STANDARD DEPARTURE CHART-INSTRUMENT

RJFN / NYUTABARU

NIPPO SEVEN DEPARTURE

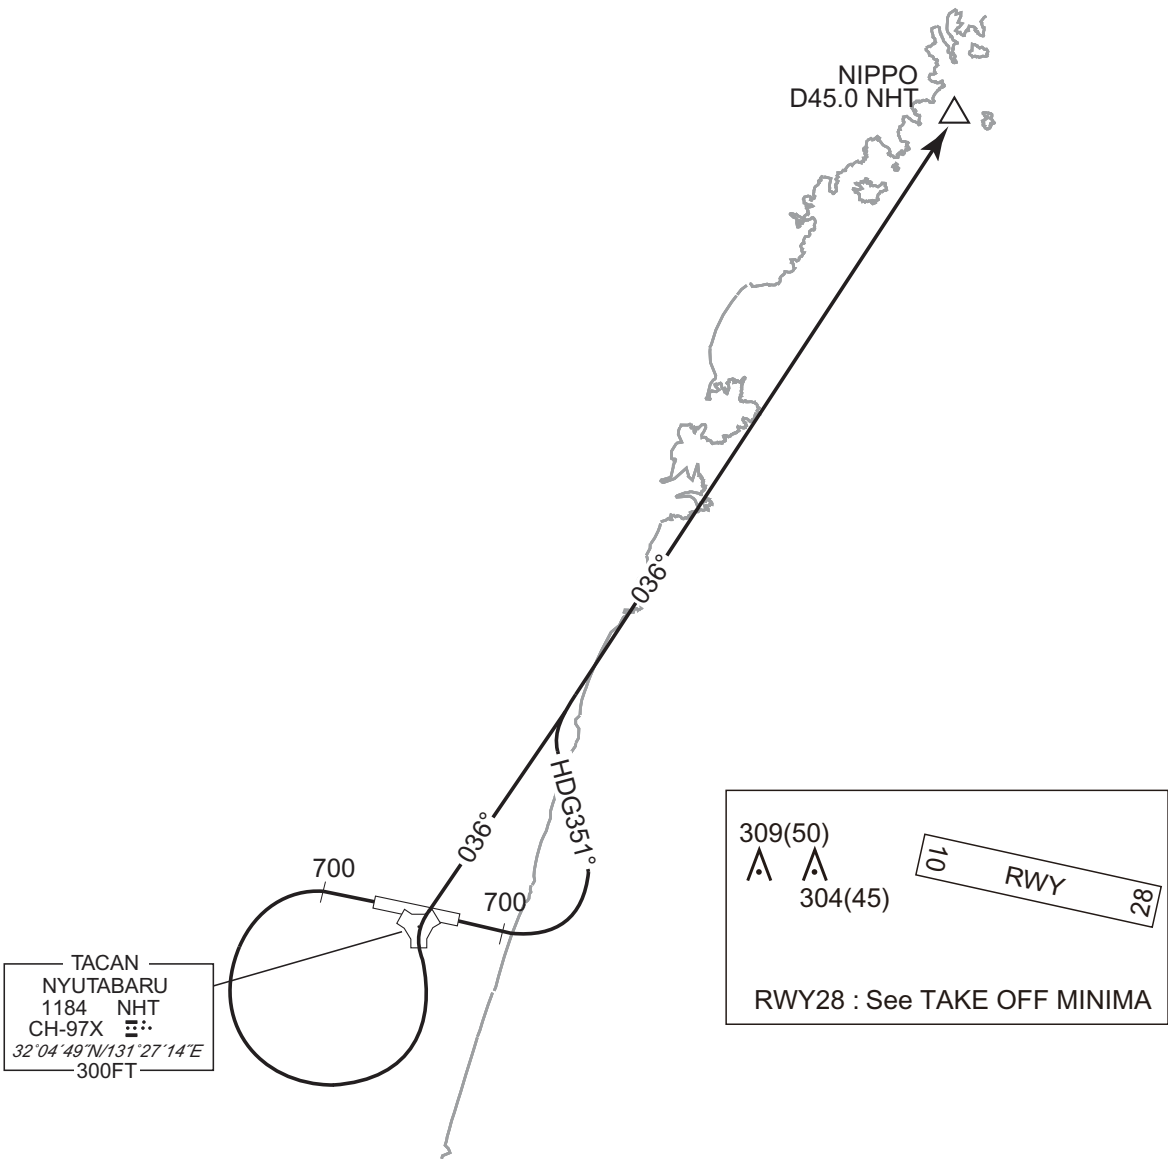
CHANGE : PROC renamed(NIPPO SEVEN DEPARTURE). PROC course(NIPPO SEVEN DEPARTURE). YATOJI TWO DEPARTURE abolished.  
Restriction. Note, OBST added.

TENSO FOUR DEPARTURE

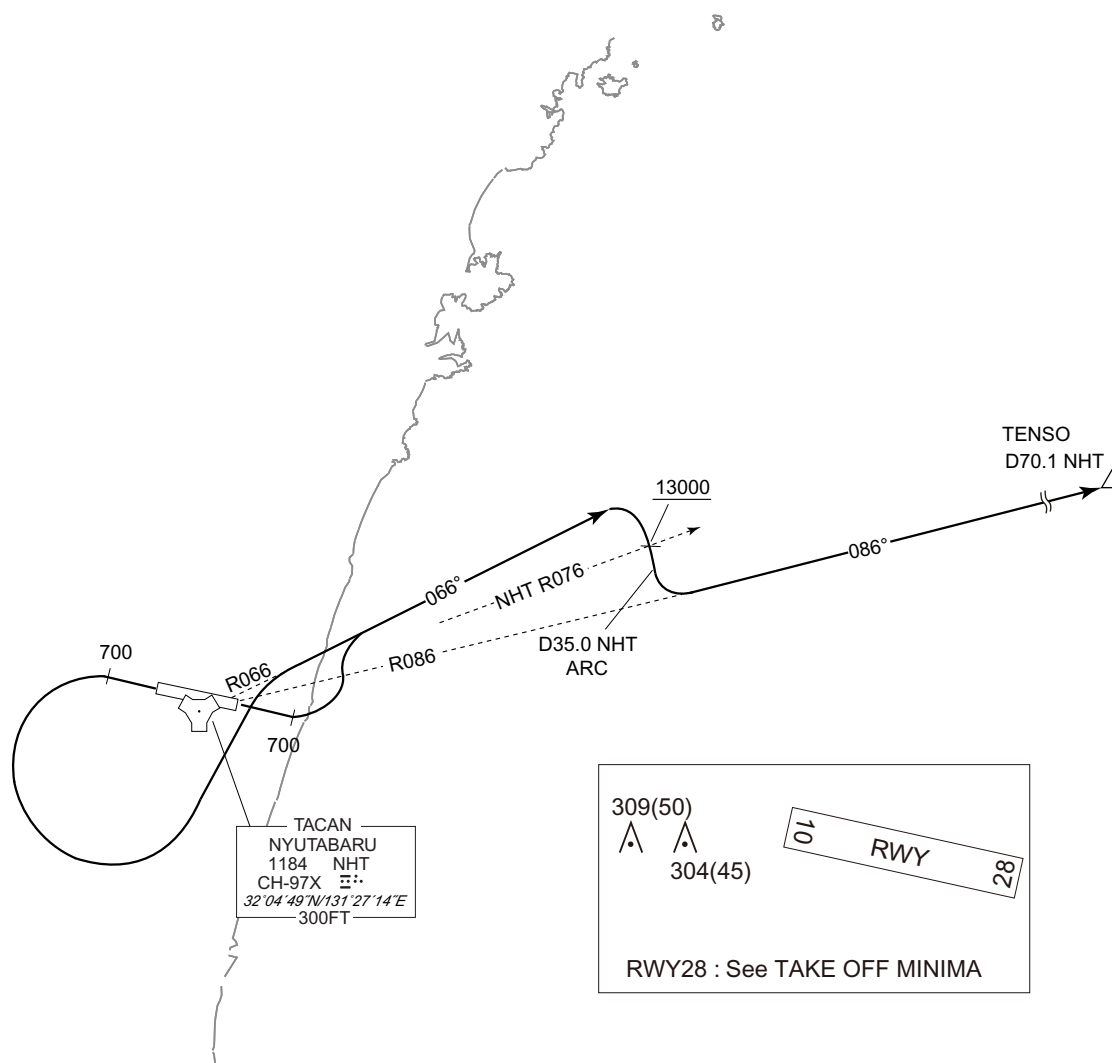
CHANGE : PROC renamed. PROC course. Restriction. Note, OBST added.

SAITO ONE DEPARTURE

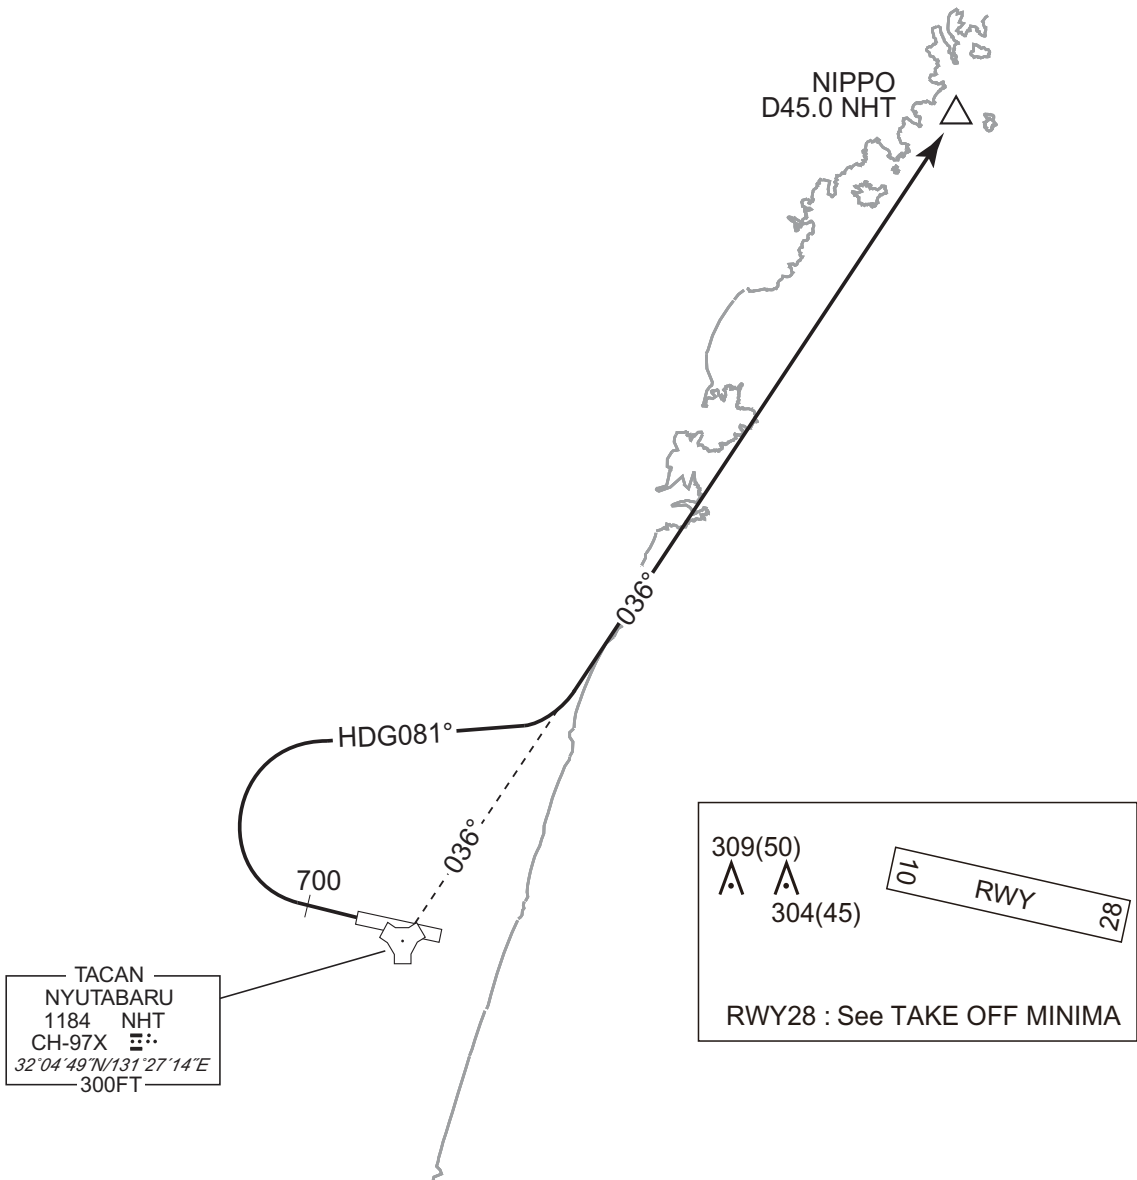
CHANGE : New PROC.

TRANSITION

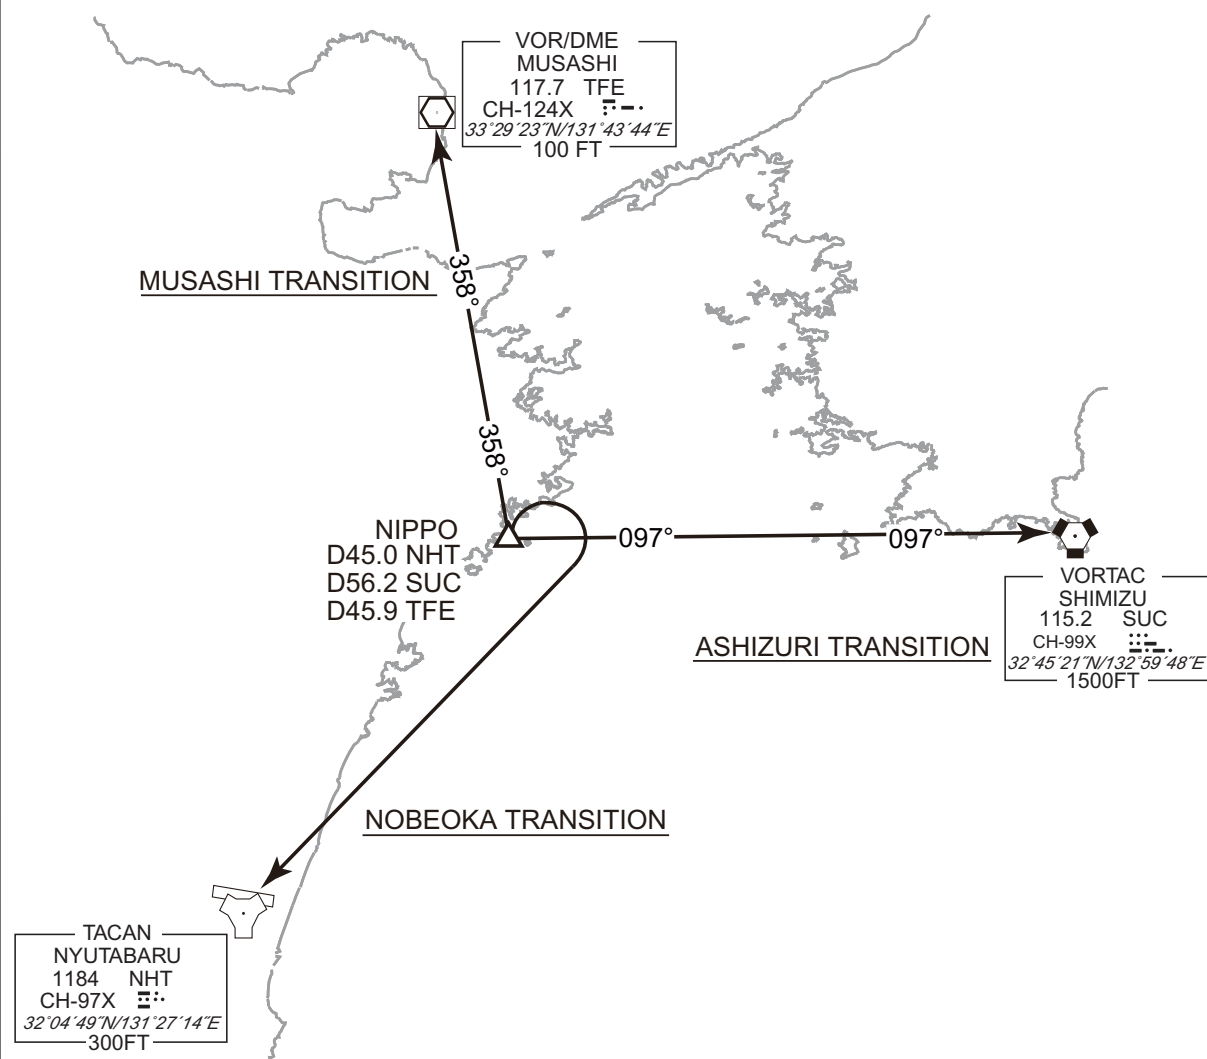
CHANGE : PROC course(NOBEOKA TRANSITION). Description of ASHIZURI TRANSITION, MUSASHI TRANSITION, MUSASHI TRANSITION. ALT restriction.  
SOBO TRANSITION abolished.

TENSO ARRIVAL

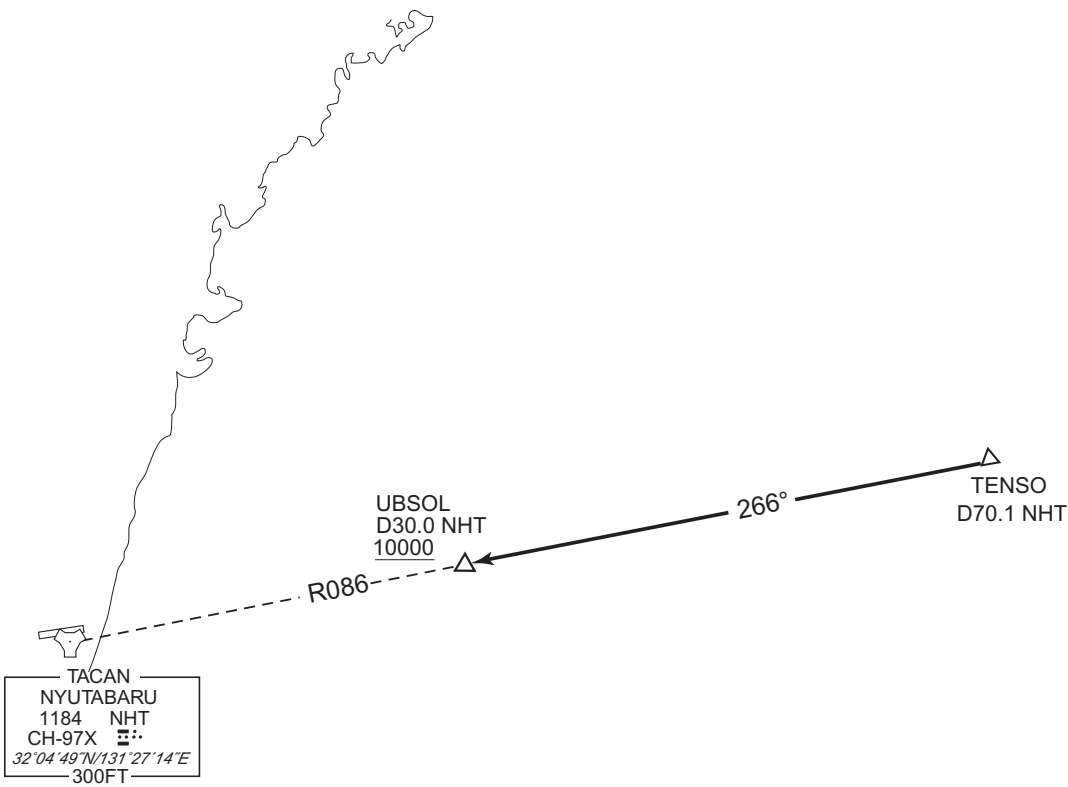
CHANGE : PROC course. UBSOL established. ALT restriction.

TACAN Z RWY28

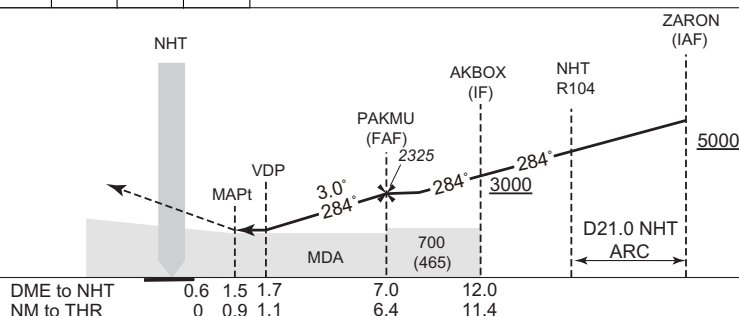
CHANGE : PROC course. Missed APCH course. MINIMA. PAKMU,AKBOX established. NM to THR.ALT(3.0°APCH Path), DME to NHT added. Missed APCH climb gradient MNM added. VAR.

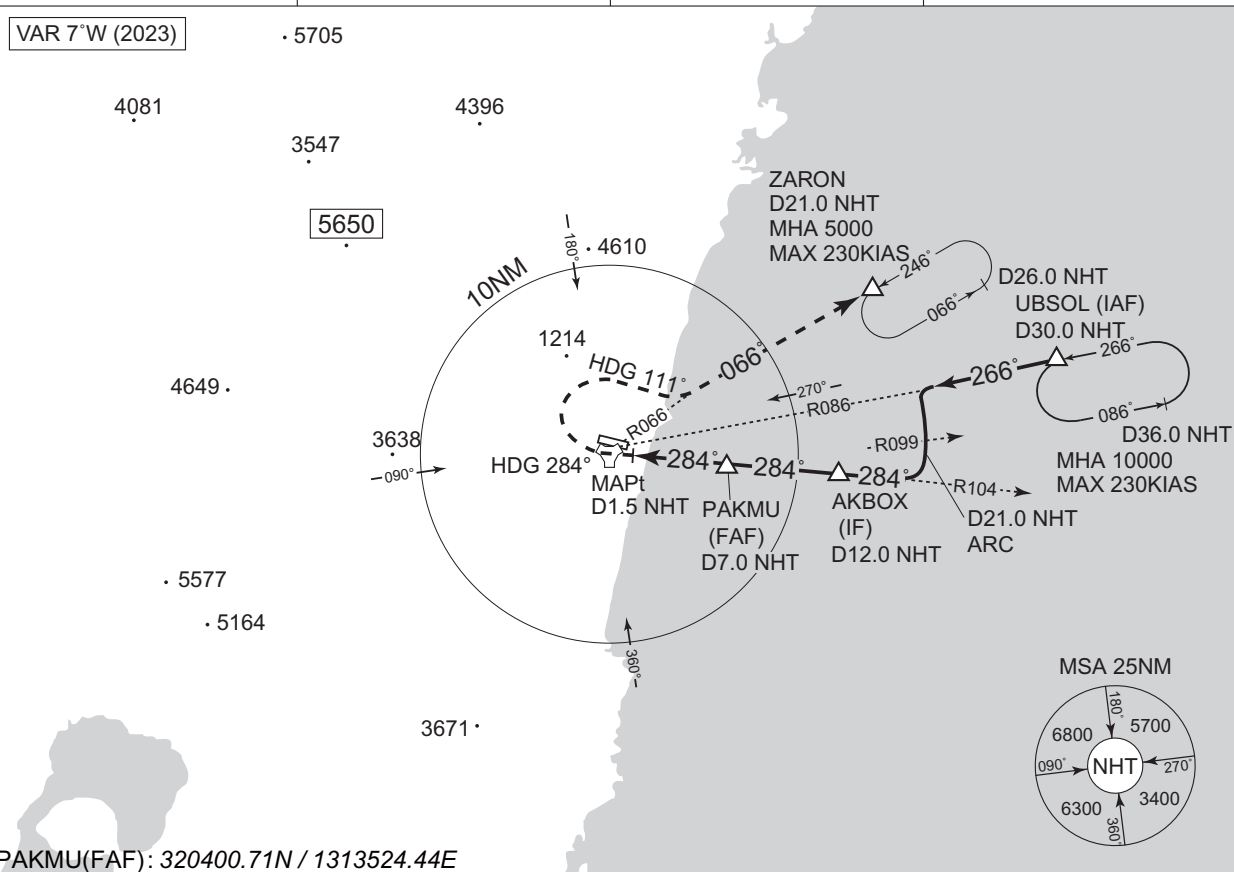
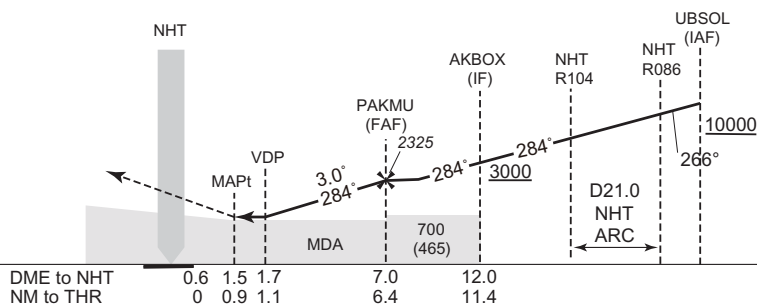
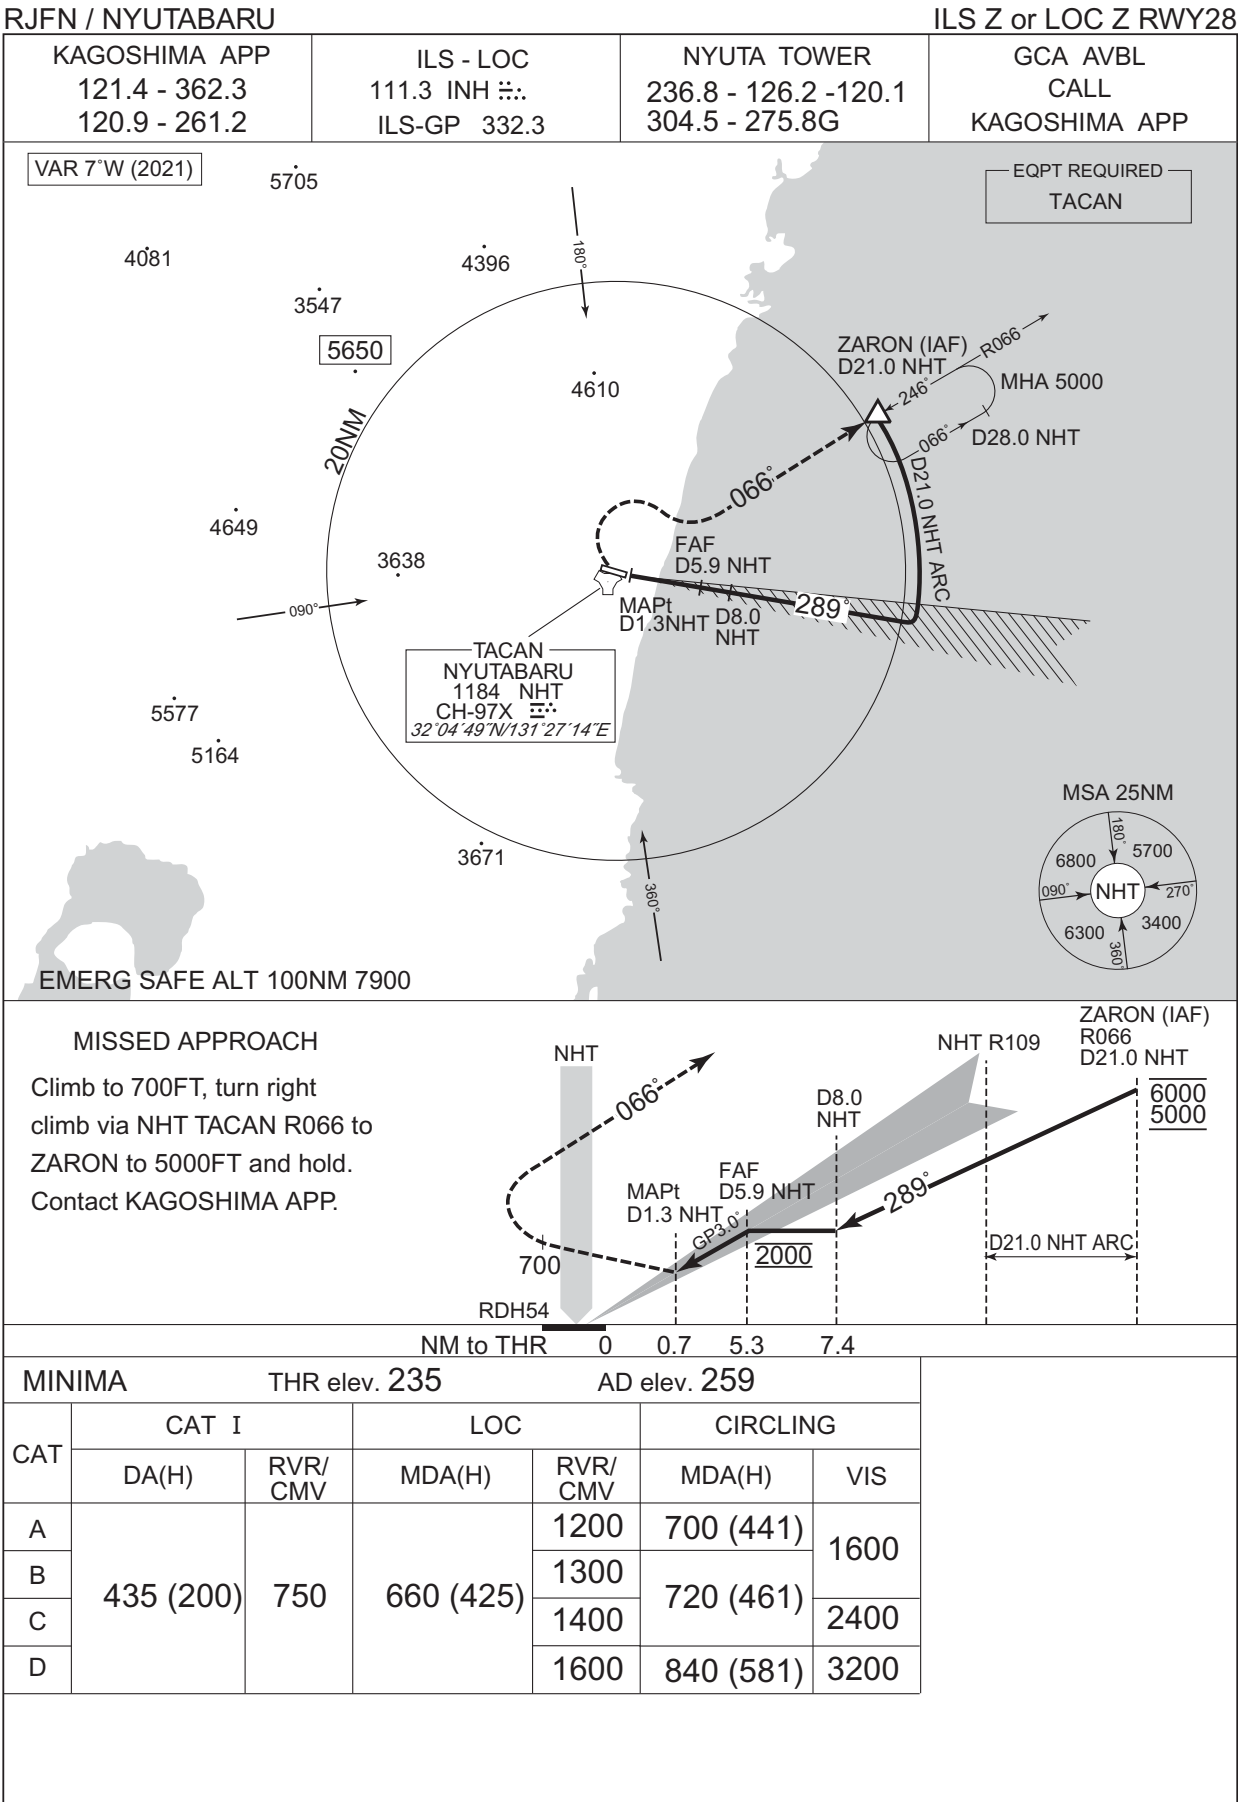
CHANGE : PROC course. Missed APCH course. MINIMA. UBSOL, PAKMU, AKBOX established. NM to THR. ALT(3.0°APCH Path), DME to NHT added.  
Missed APCH climb gradient MNM added. VAR.
